PORT MACKENZIE

RAIL EXTENSION

MSB Trails Meeting

MSB Trail Meeting Comments and Responses - October 27, 2011

5. Unnamed Tributary to the Little Susitna River (H 6.3)

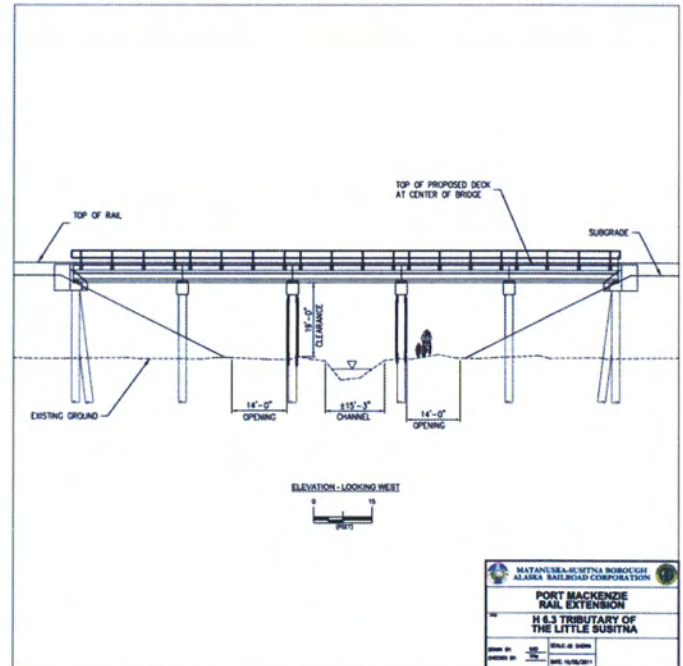
5. Reroute under Crossing 6.3 (Project Crossing #5)		
Reference #	Comment	Response
5a.	Too much traffic for one crossing.	This proposed crossing is a 5 span bridge with a northern and southern access span of over 20' in width. The spans will accommodate a trail on both the north and south side of the creek. The outside spans will be widened from 14' to over 20' to accommodate groomers and multiple users.
5b.	Need a wider turn radius for the reroutes coming under the crossing location.	The turn radius for the reroutes under both the north and south spans will be modified and designed for a 100' vehicle to turn and pass under the structure.
5c.	Mushers need 85' in length for 16 to 20 dog teams; curve is too tight.	The outside spans will be widened from 14' to over 20' to accommodate dog teams with sleds of this length. The trails approaching the crossing will also be designed with curves to accommodate this length.

5d.	Want wider openings at the crossing location (H 6.3); this crossing should be 25'3" wide like the other locations.	The design of reroutes will allow for sufficient line of sight for all user groups and traffic will be accommodated by two parallel trails one on each side of the creek. The trail groomer will be able to maintain access on the north and south spans of this crossing structure via existing trail connectivity.
5e.	Need a good line of sight coming under the crossing.	The turn radius for the reroutes under both the north and south spans will be modified and designed for a 100' vehicle to turn and pass under the structure. Trails will be aligned to provide increased site distance.
5f.	The stream at crossing H 6.3 tends to have overflow, making a trail crossing problematic.	Trail embankments will be designed to minimize impacts from overflow.
5g.	Crossing signs needed at this location.	Proposed signs include: • Clearance signs • Slow – Keep Right High Traffic Area • Caution dog teams on trail

9. Iditarod Historic Trail
Cost = \$1,550,000

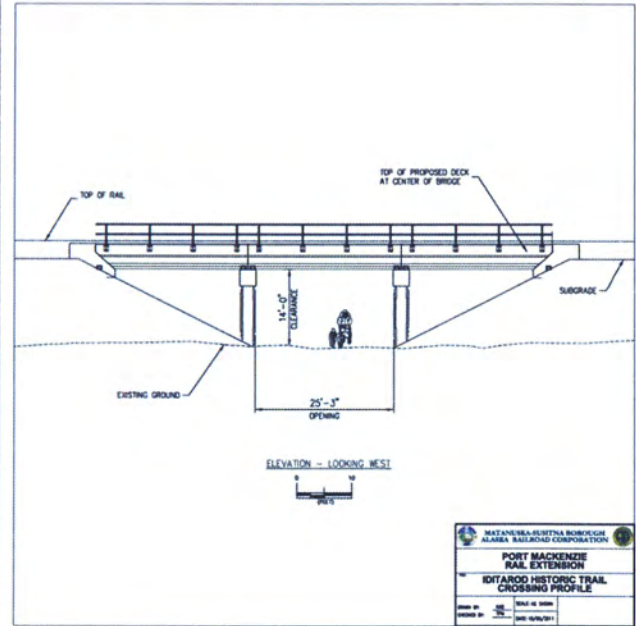
2. Historic Iditarod Trail (Project Crossing #9)

Reference #	Comment	Response
2a.	The Historic Trail needs improvement; it is too narrow for current and potential increased use.	Trail improvements are planned for the Historic Trail including trail widening in the vicinity of the rail embankment and reroutes.
2b.	The Historic Trail west of the crossing location near the Little Susitna washes out and is in ill repair, needs fixed (bridge needed).	Access to the 'race' trail will still be possible west of the alignment before the Historic Trail crosses the Little Susitna River.
2c.	The Historic Trail is not used as frequently as the race trail.	The Historic Trail will be improved in the vicinity of the crossing making it more likely to be used. To aid trail users, a kiosk identifying the user's location on a trails map will be installed to identify trail reroutes and show available trail connections.
2d.	Crossing signs are needed at this location	Proposed signs to be installed at the crossing include: • Caution dog teams on trail • North/South arrows • Slow – Keep Right High Traffic Area • Clearance 14'
